City of Lake Elmo Planning Department
Preliminary & Final PUD Plan/Plat

Request: The Northeast Metro Intermediate School District 916 is seeking approval of a preliminary and final plan/plat for Eagle Point Business Park 8th Addition within the Eagle Point Business Park.

To: Ben Gozola, Senior Planner, Sambatek
Cc: Kyle Klatt, Planning Director
From: Jack Griffin, P.E., City Engineer
Re: ISD 916 Intermediate School Building
Final Plat/Construction Plan Review

Sheet No. 200.CU

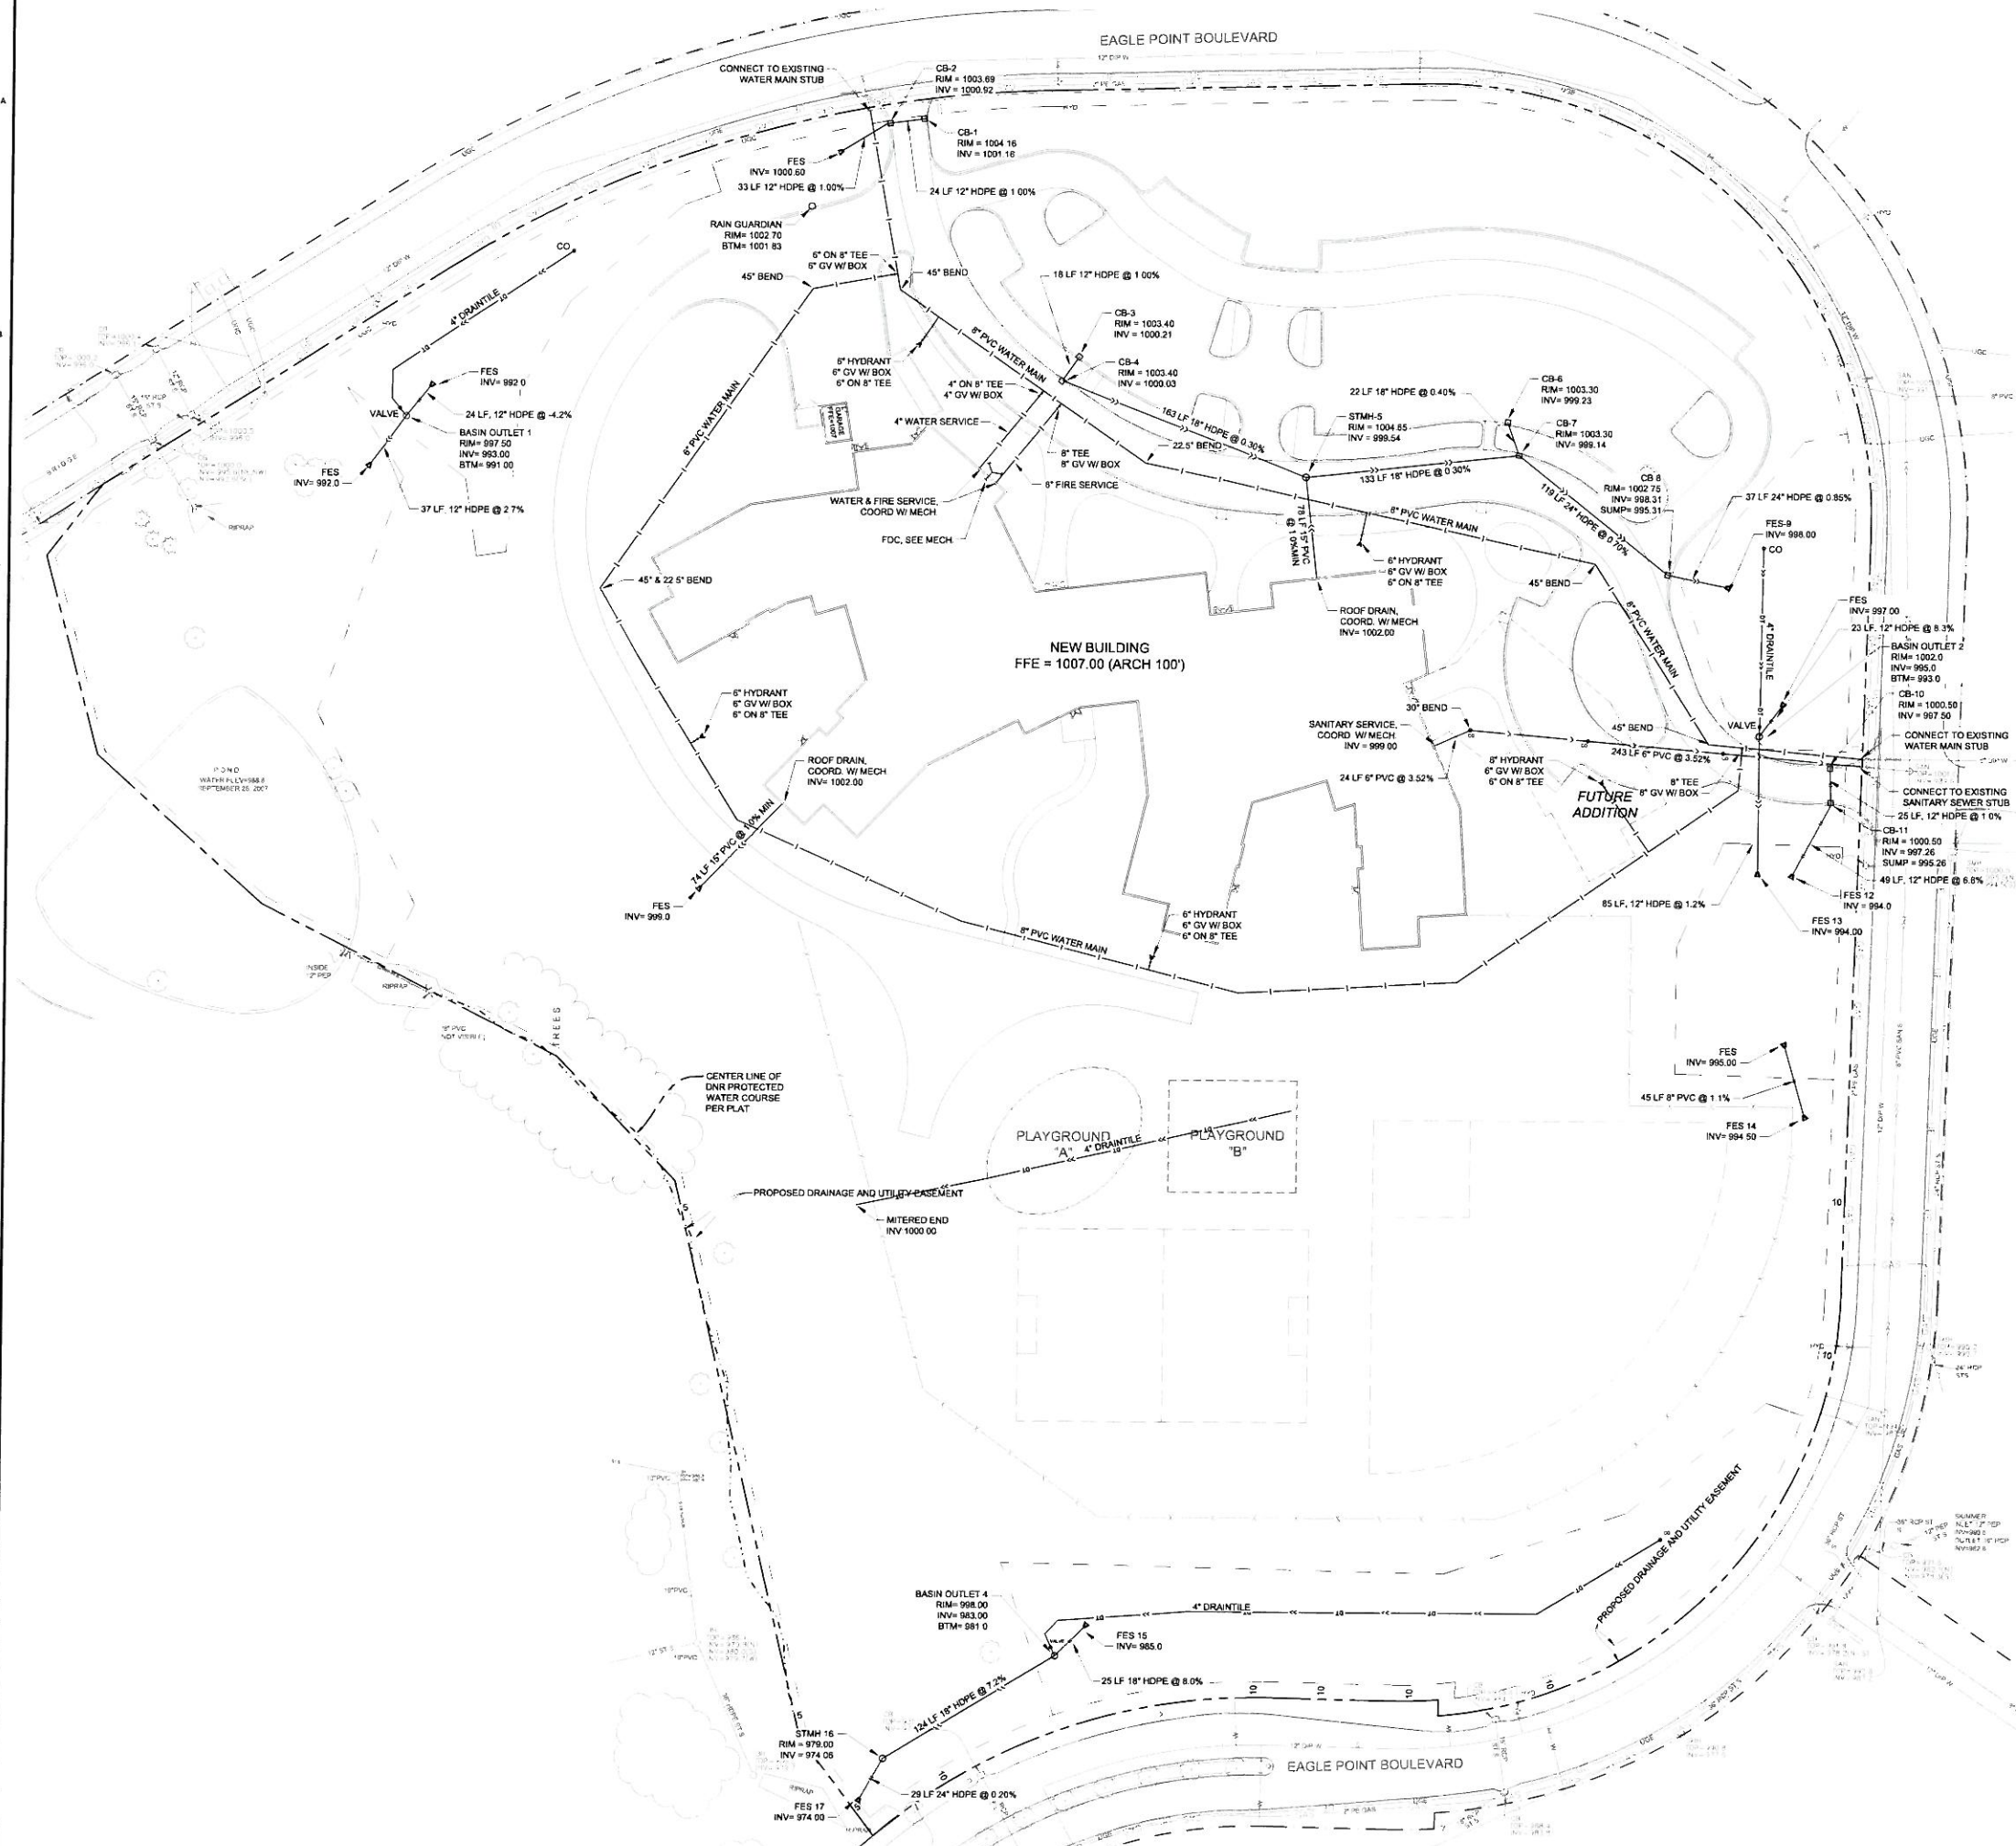
6. Sheet 200 CU:
- Connection to existing sanitary sewer stub. The project proposes to connect to the existing 8-inch sanitary sewer stub located in Eagle Point Boulevard. A 6-inch private service line is proposed to connect to the building. No public utilities are proposed.

- Connection to existing watermain stub. The project proposes to connect to an existing 12-inch watermain at two locations within Eagle Point Boulevard to create a looped watermain network. In addition, an 8-inch watermain is also proposed interior to the site and looped around the building with 5 hydrants for fire protection. A 4-inch water service line and 8-inch fire service line are proposed to connect to the building (private service lines). The interior site watermain loop with hydrants must be publically owned and maintained. Easements must be provided as part of the revised Plat.

- The City minimum pipe size is 8inch. The 6-inch watermain shown on the northwest side of the building must be revised to 8-inch pipe.
 - City Standard Plan Notes for Watermain must be included on the Utility Plans. Any plan notes that contradict the City plan notes must be removed.

Sheet Title: LANDSCAPE PLAN

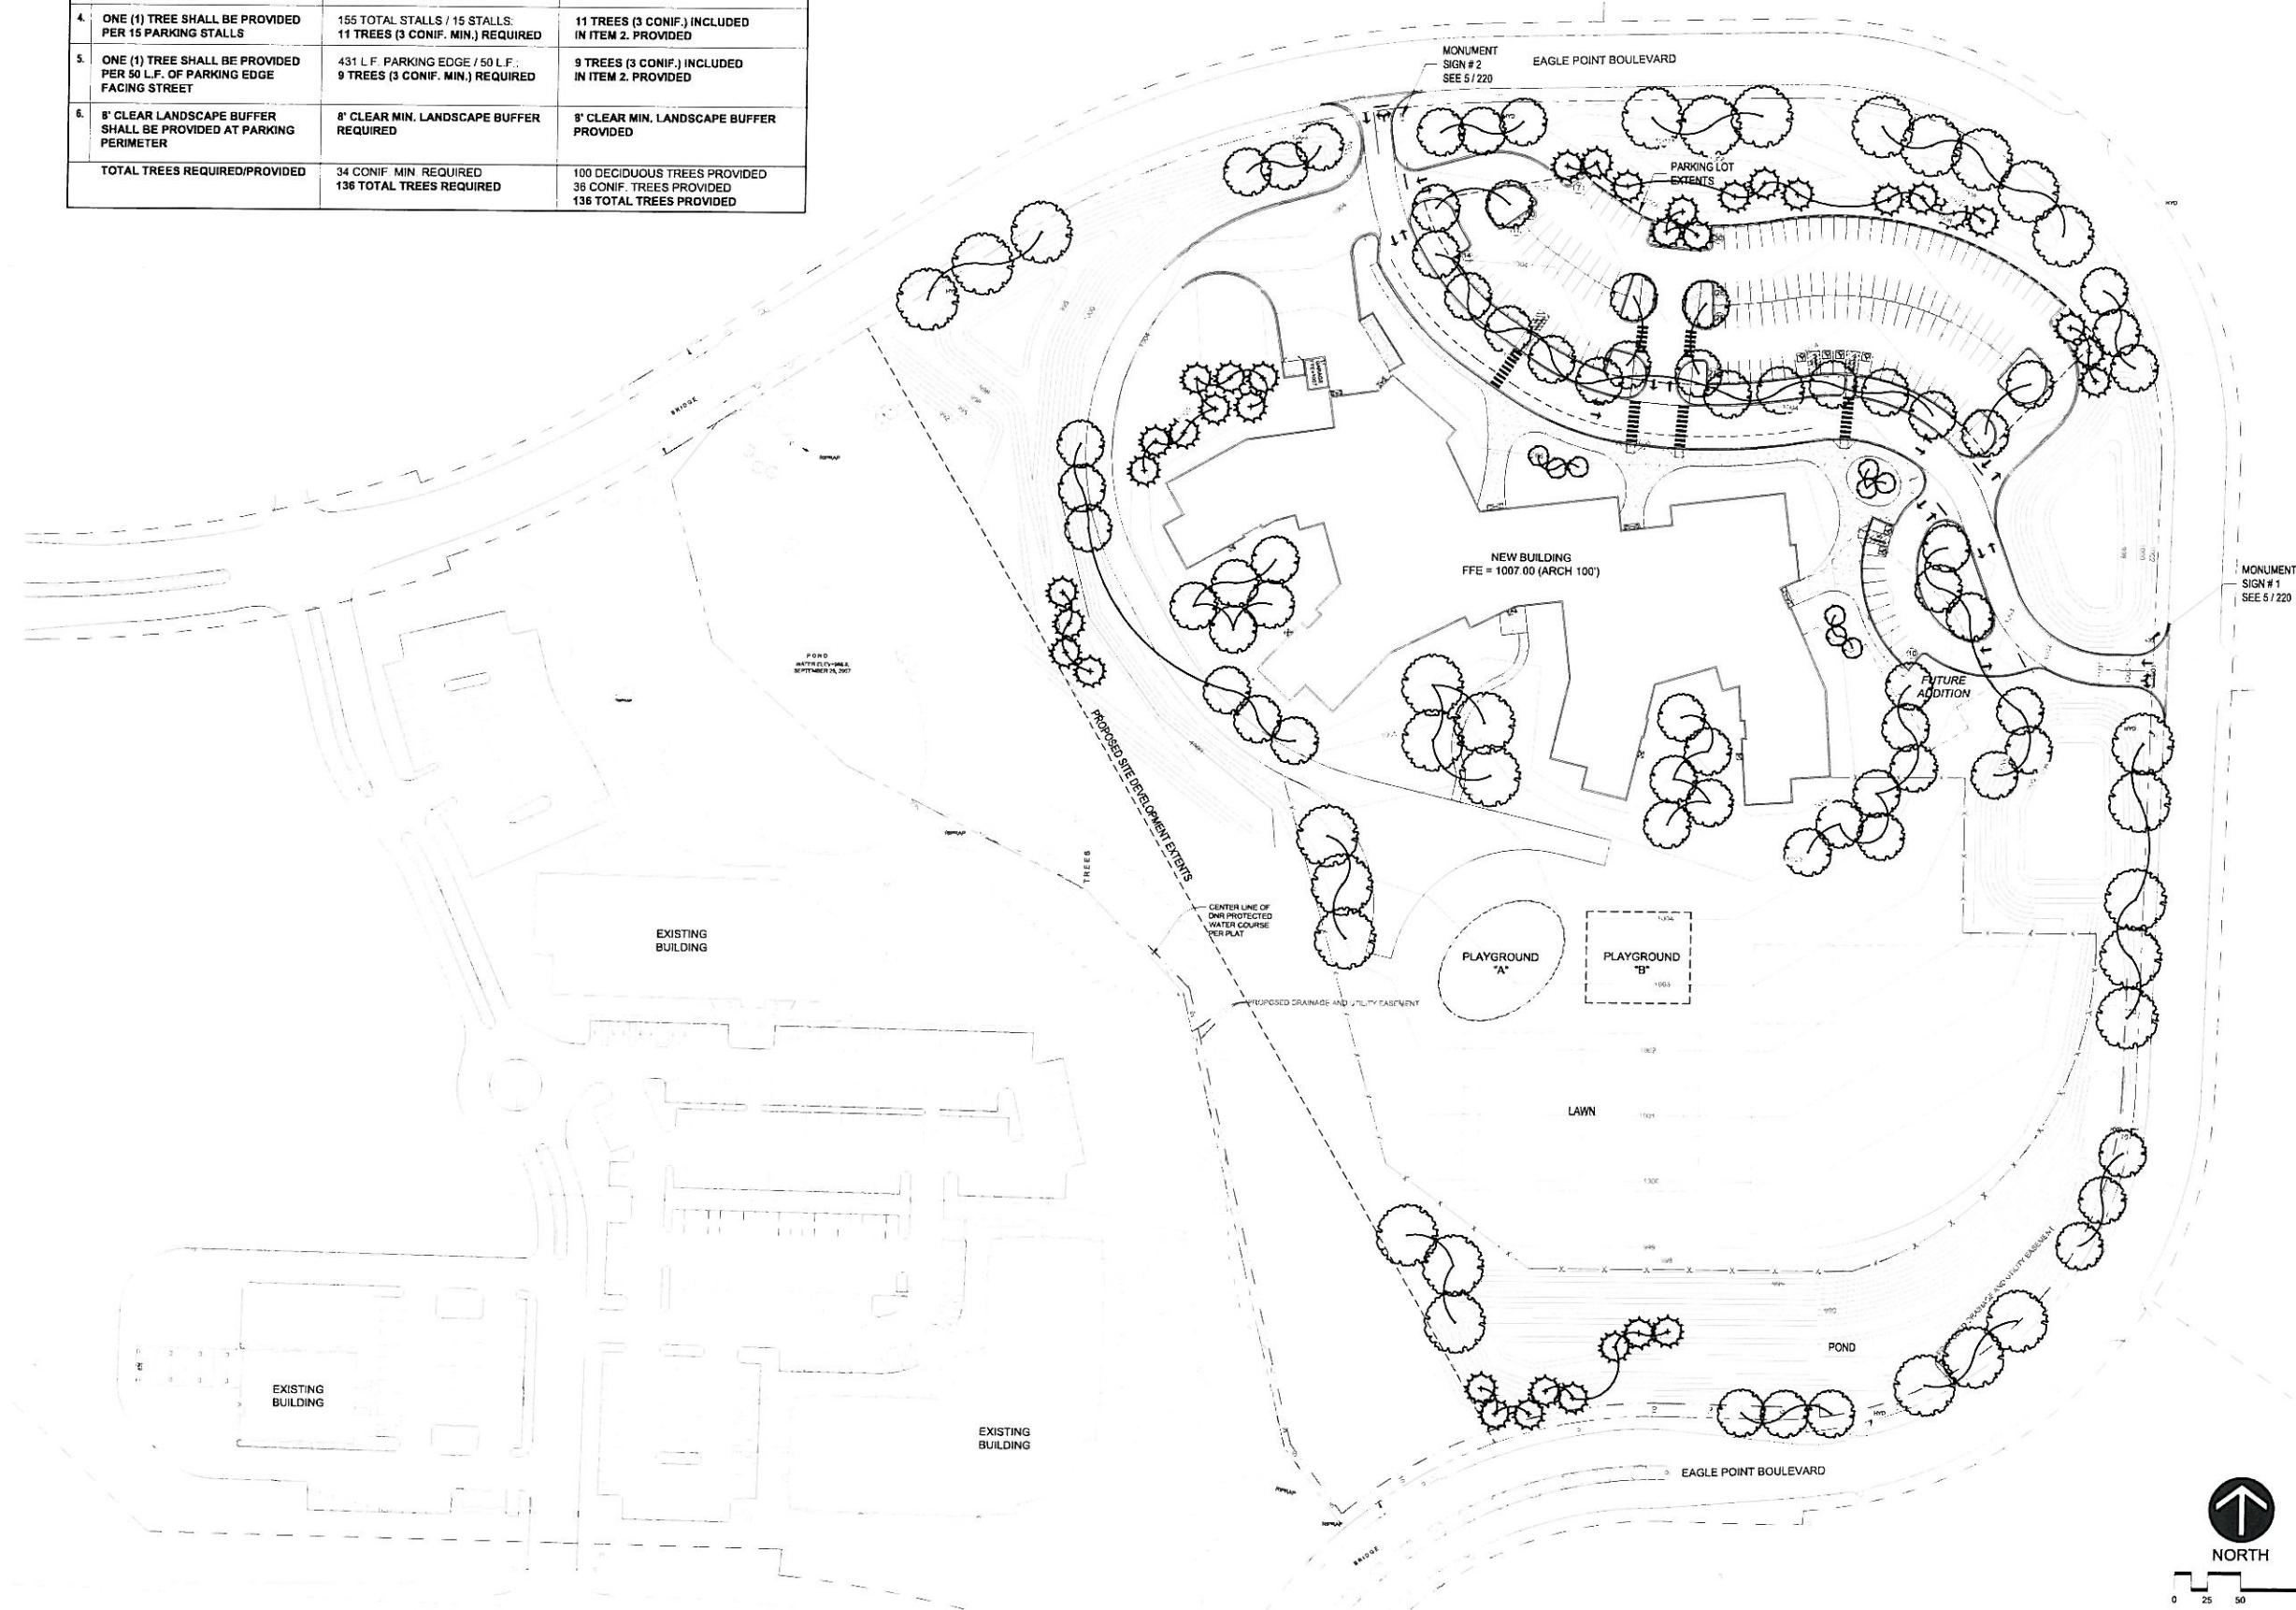
- The applicants have submitted a landscape plan that shows 84 trees being planted on site with 52 trees along the road which does comply with minimum standards.

- Per the plans, there is 56,755 square feet of parking area which requires 2,838 square feet of internal landscaping areas. The plans indicate 5,600 square feet is being provided which meets minimum requirements.

- Per plans, 154 parking spaces are being provided which requires 11 island or corner planting trees—all of which are being shown.
 - **Perimeter Parking Lot Landscaping:**

7. Sheet 200LP:
- Plan notes must be added to require the Contractor to flag all tree locations for City review and approval prior to installation. All trees must be located a minimum of 5 feet from public utilities.
